# Pleasant Ridge Sound Study Data

By  
John Slagel

Exhibit 3

Figure 7-1: Noise Levels versus Ground Wind Speed – Prime 2

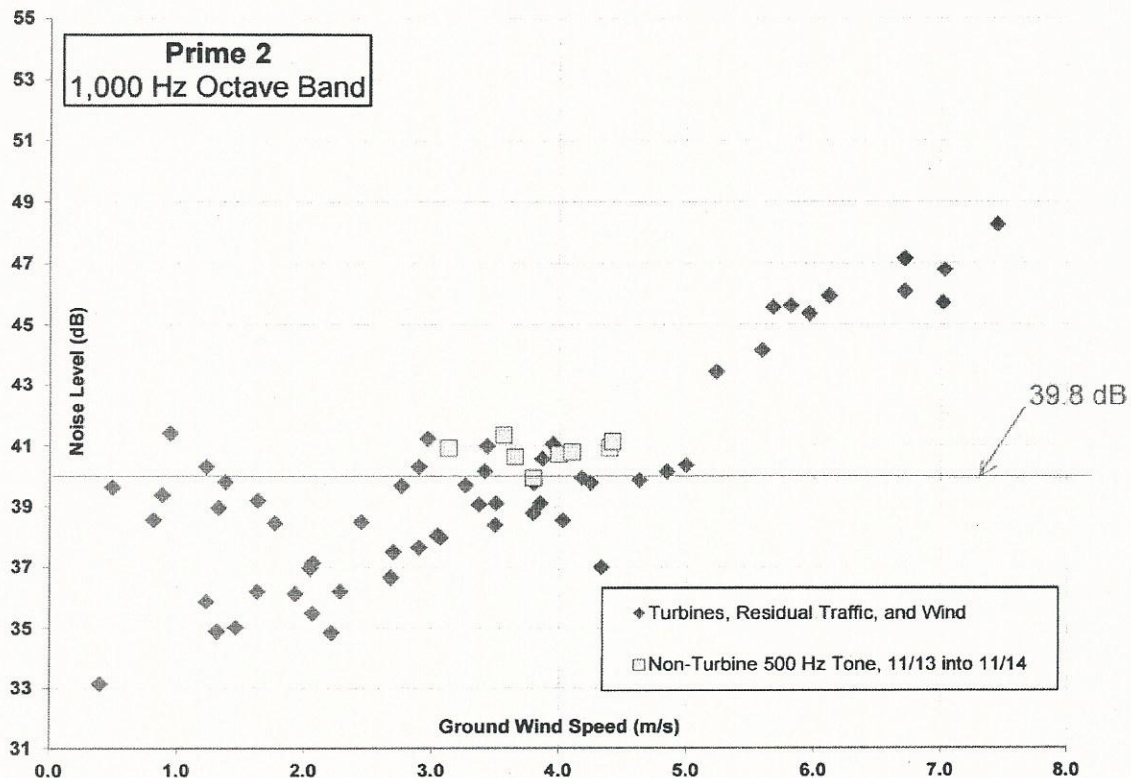
- We just need two pieces: A validated measurement and a model.
- Puzzle Piece 1: “The measurement” PR Exhibit 48, Noise Level Compliance Analysis for the California Ridge Project, specifically, monitored location Prime 2, which included wind speed measurements.
- Puzzle Piece 2: “The model” Using ISO 9613-2 Worst Case Conditions (IWCC), I modeled IWCC Predicted @ 1000Hz for Prime 2 (Answer:39.8 db).
- So the readings should be 39.8 db worst case, according to IWCC Predictions.

Fig 1  
1000 Hz Octave  
Band Contours

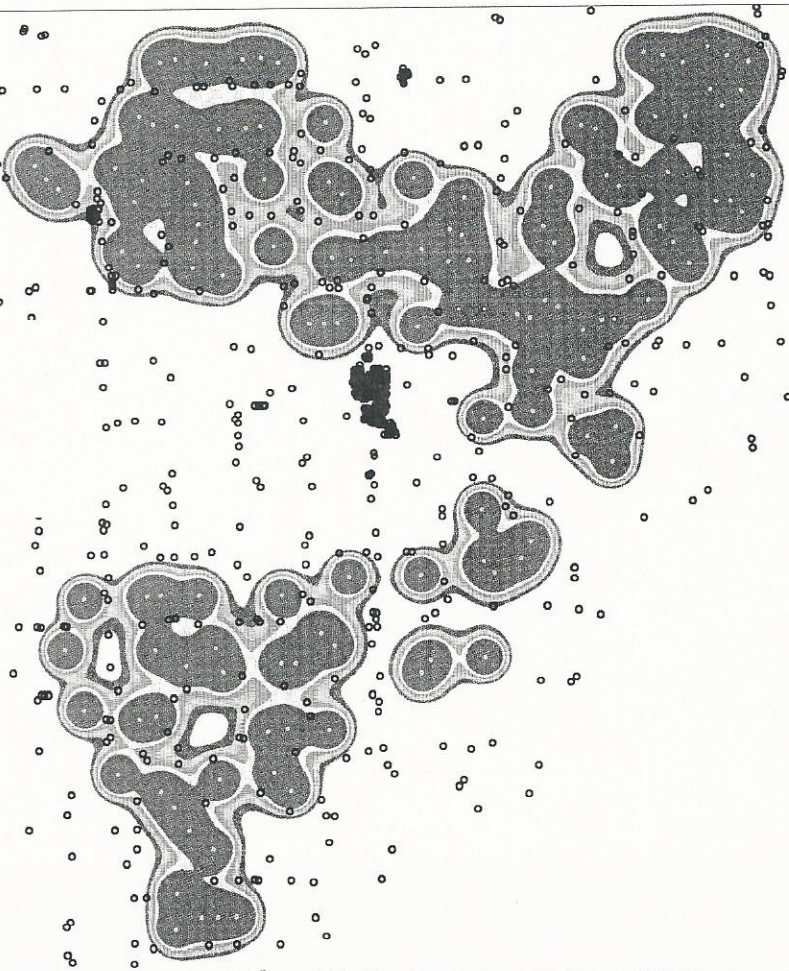
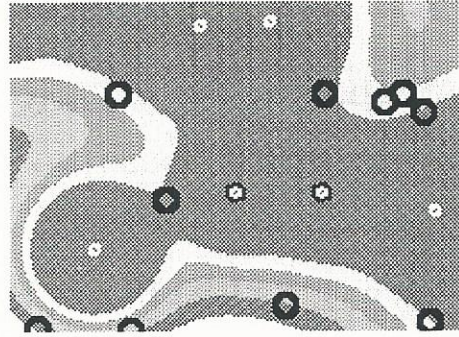
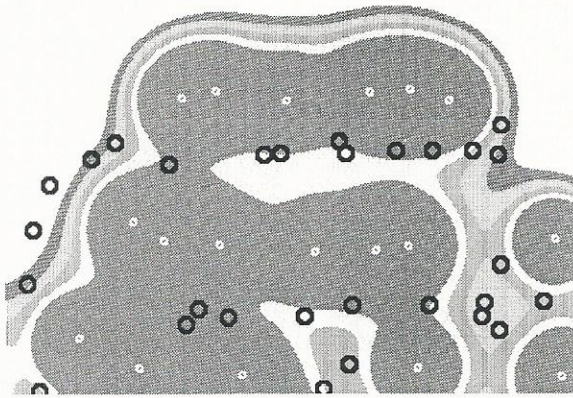
Original 8/20 PR  
application Data,  
4 LNTEs.

Quite a few points  
are clearly over  
the IPCB limit of  
41 dB.

Fig 2  
1000 Hz Octave  
Band Contours

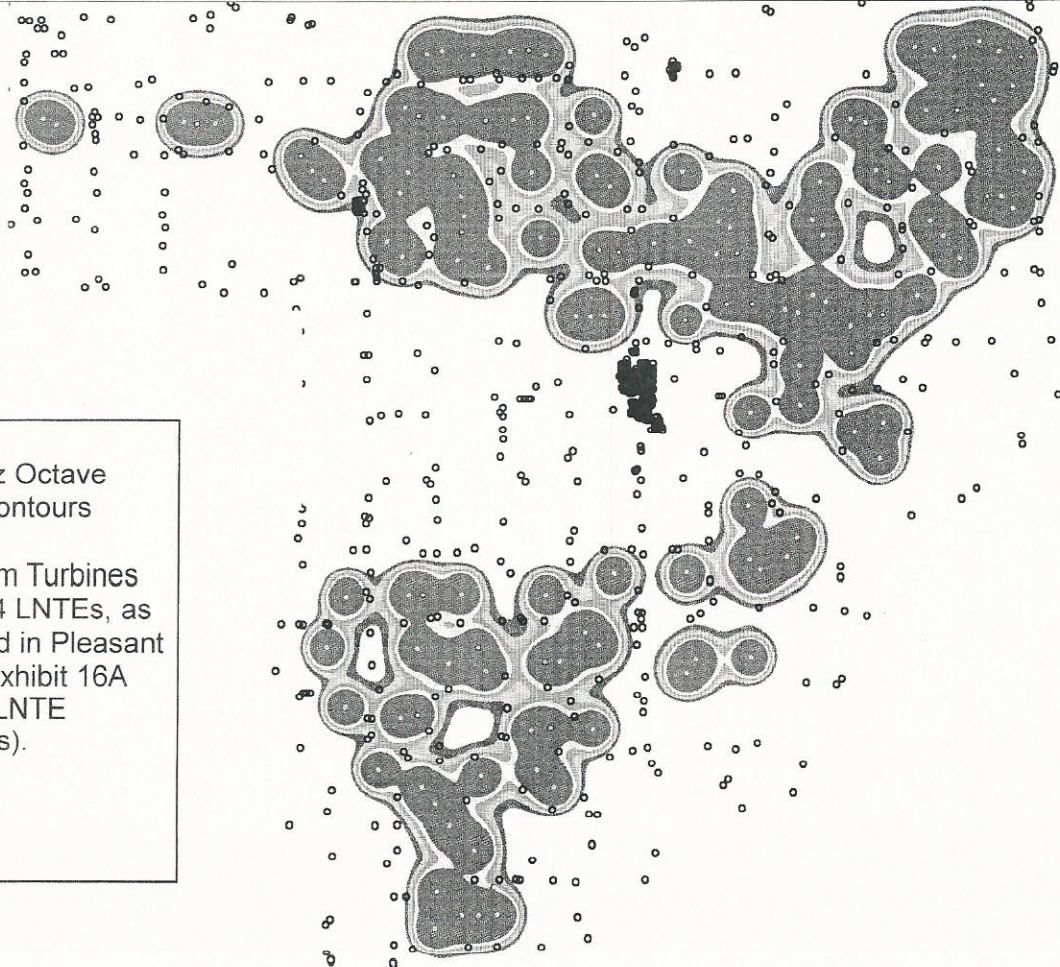
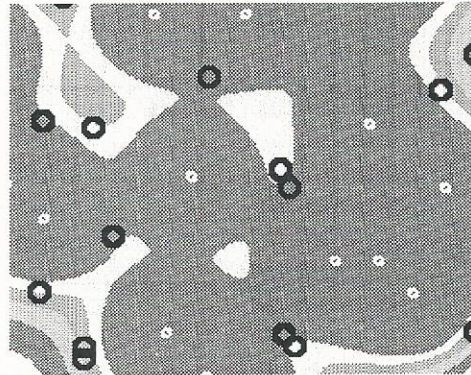
Original 8/20 PR  
application Data,  
4 LNTs.

Zoomed in on a  
some of the bad  
areas.

Fig 3  
1000 Hz Octave  
Band Contours

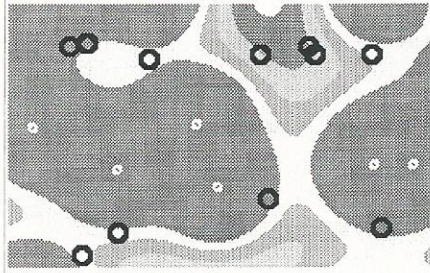
PR 100m Turbines  
using 24 LNTs, as  
specified in Pleasant  
Ridge Exhibit 16A  
(List of LNT  
locations).

Fig 4  
1000 Hz Octave  
Band Contours

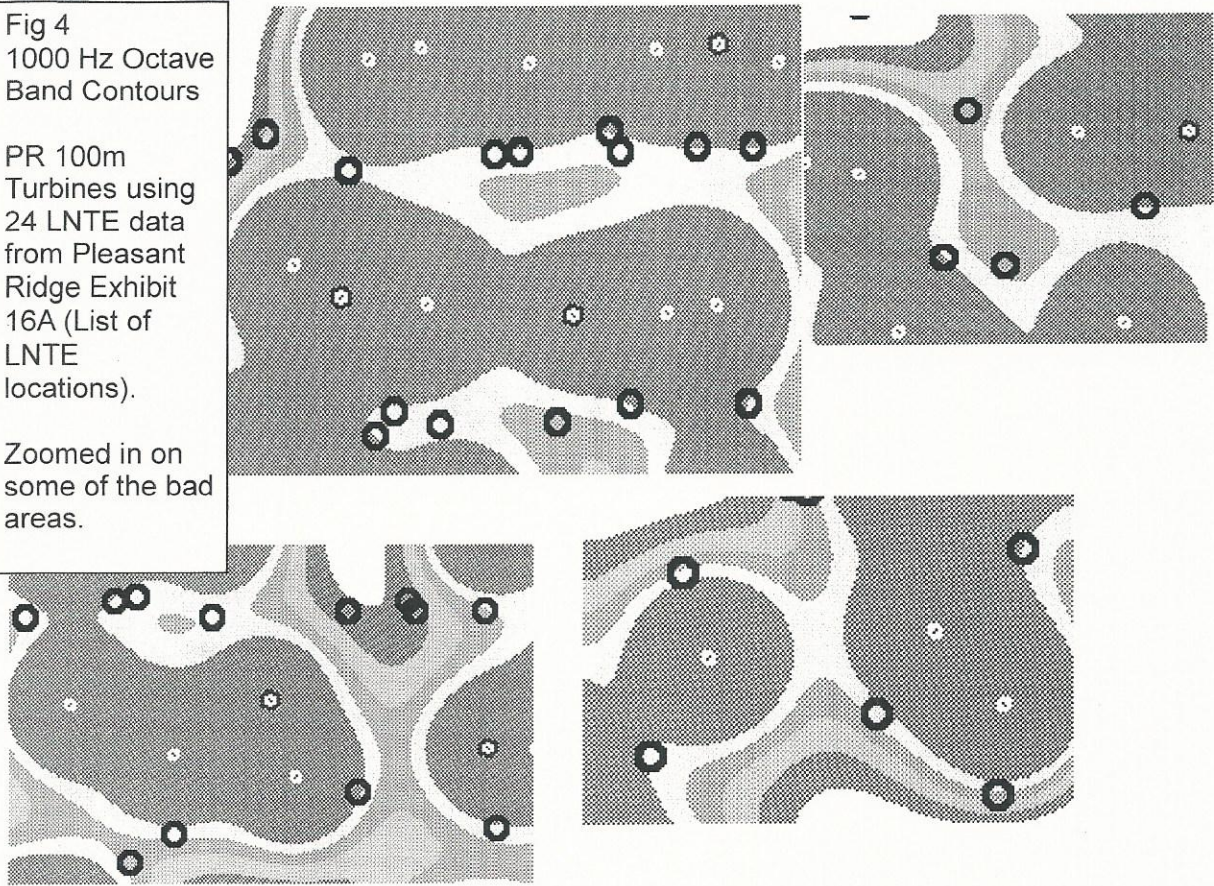
PR 100m  
Turbines using  
24 LNTE data  
from Pleasant  
Ridge Exhibit  
16A (List of  
LNTE  
locations).

Zoomed in on  
some of the bad  
areas.

Fig 6  
1000 Hz Octave Band Contours

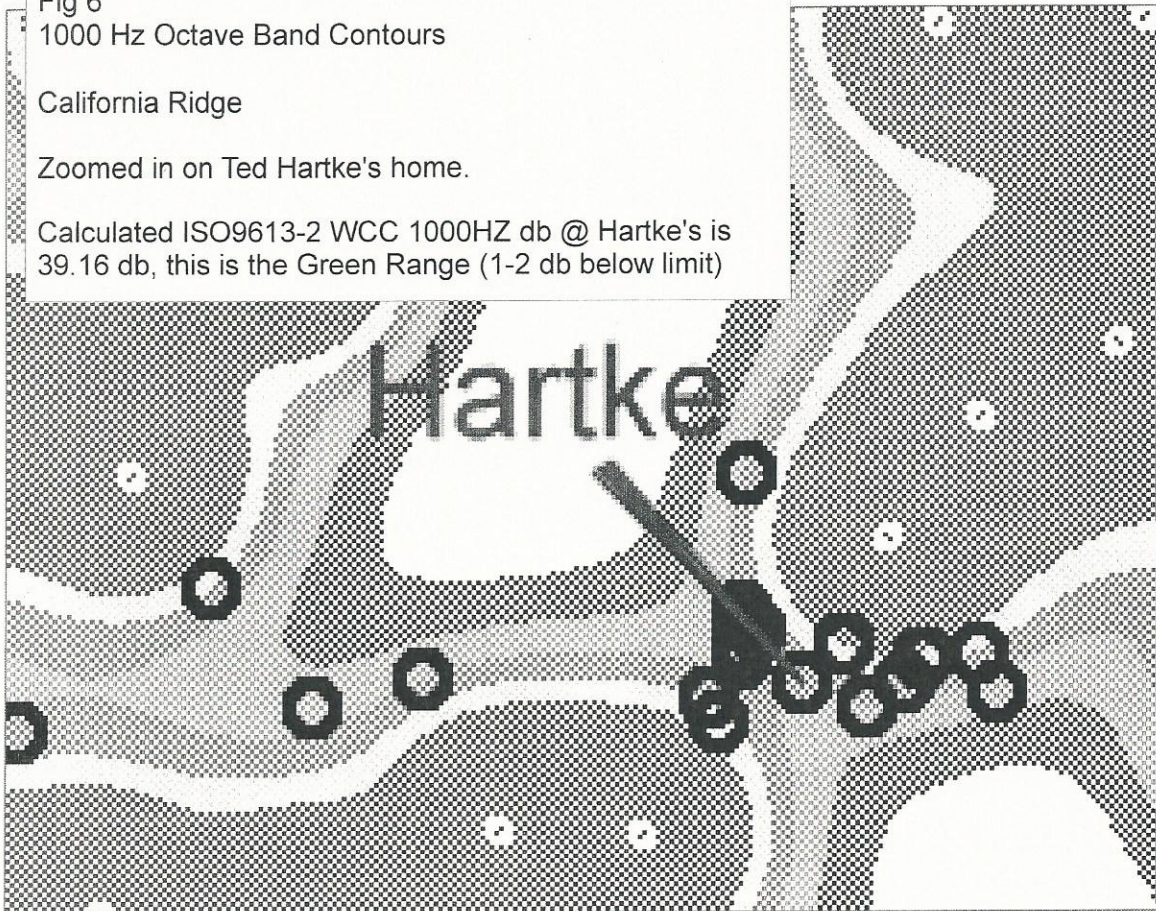
Zoomed in on Ted Hartke's home.

Calculated ISO9613-2 WCC 1000HZ db @ Hartke's is  
39.16 db, this is the Green Range (1-2 db below limit)

Fig 7  
1000 Hz Octave Band  
Contours

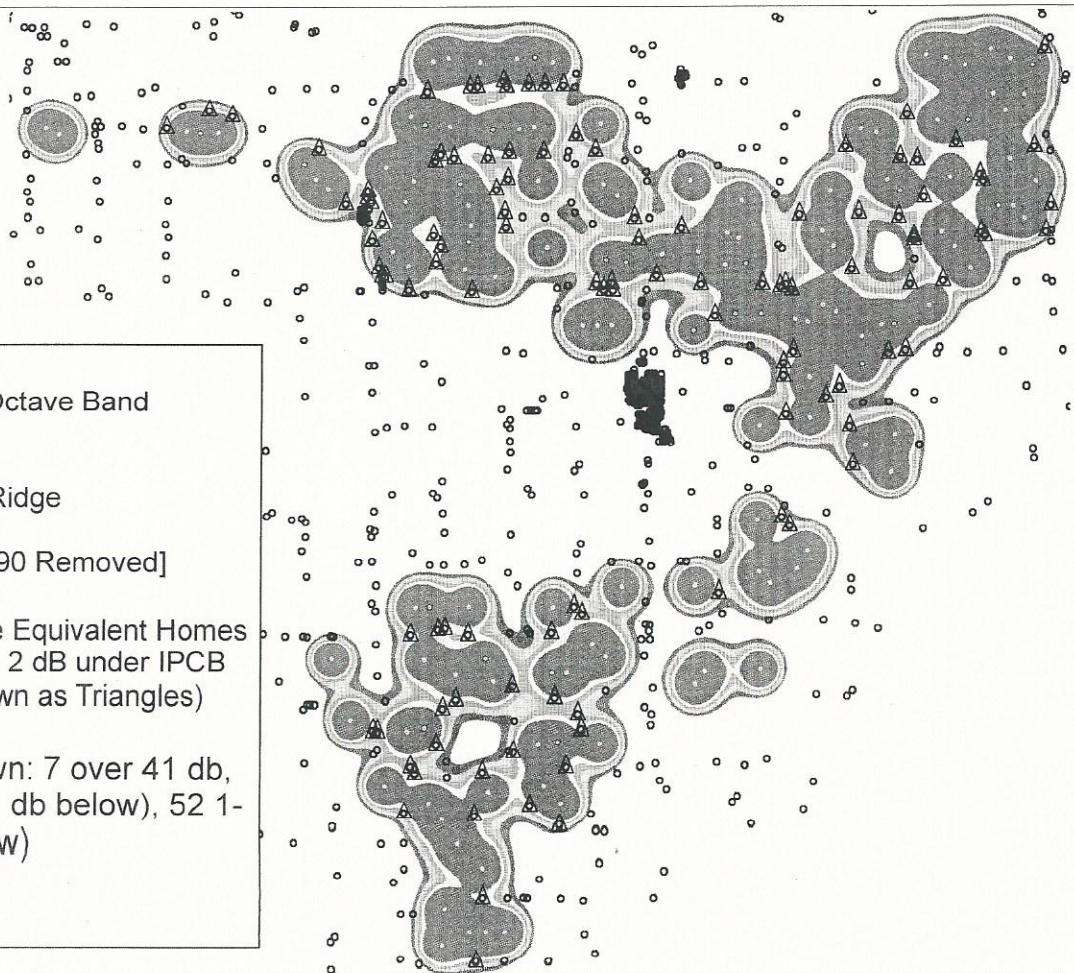
[Turbine 090 Removed]

114 Hartke Equivalent Homes  
(Less than 2 dB under IPCB  
limits, shown as Triangles)

Breakdown: 7 over 41 db,  
55 at (0-1 db below), 52 1-  
2 db below)
